Th11b

MEMORANDUM

Subject: **Addendum to Commission Meeting for Thursday, April 10, 2014**
North Coast District Item Th11b, CDP No. 1-10-002
(Del Norte Veterans Monument Committee)

Regarding: 1-10-002; Erection of a public monument to honor area military veterans

Figure 1: Photo Vantage Points (red) and Coastal Blue-Water View Affected Area (blue)

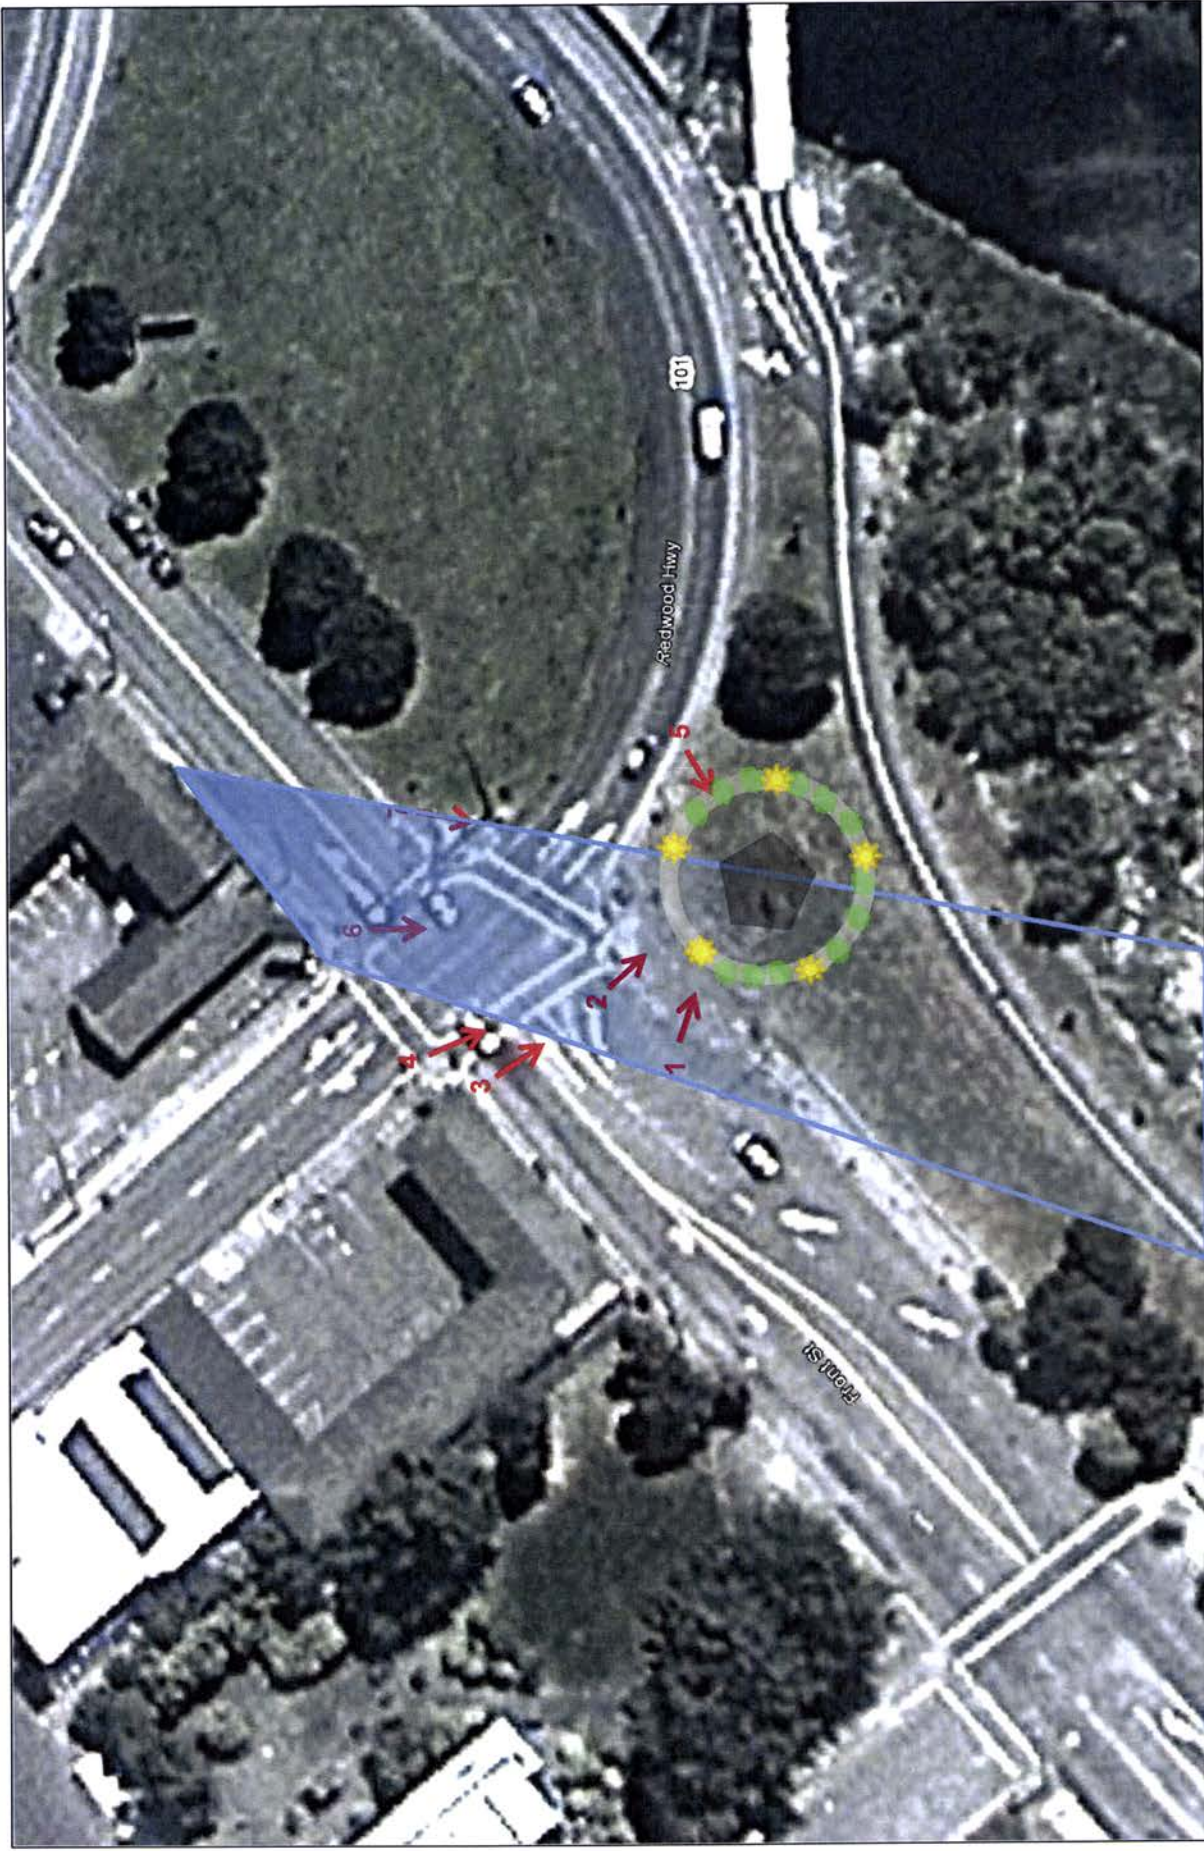
Comment from Friends of Del Norte: We also value the scenic views of the estuary and tidal flats at this location, which is the first most splendid glimpse of coastal nature within town for southbound visitors along Hwy 101. The proposed veterans monument will block this important

scenic view from southbound Hwy 101, and will degrade the natural beauty here. Although attractive, the hard monument is visually incompatible with the natural scenic views of the estuary. We therefore find that the monument is inconsistent with Coastal Act Section 30251.

We also value the scenic views of the estuary and tidal flats at this location, which is the first most splendid glimpse of coastal nature within town for southbound visitors along Hwy 101. The proposed veterans monument will block this important scenic view from southbound Hwy 101, and will degrade the natural beauty here. Although attractive, the hard monument is visually incompatible with the natural scenic views of the estuary. We therefore find that the monument is inconsistent with Coastal Act Section 30251.

Response: As discussed in the March 21, 2014 staff recommendation, Commission staff considered the effects of the proposed monument on visual resources of the surrounding area. Although the project would result in some blockage of the existing harbor views from the U.S. 101 and Front Street roadways, the degree to which the harbor view is impeded is limited and coastal views would continue to be afforded from these vantage points. Moreover, pedestrian and bicycle access around and behind the monument affording views to and along the shoreline would not be precluded and remain publically accessible. Accordingly, Commission staff continues to recommend that the Commission find the monument project, as conditioned, protects coastal views consistent with Coastal Act section 30251.
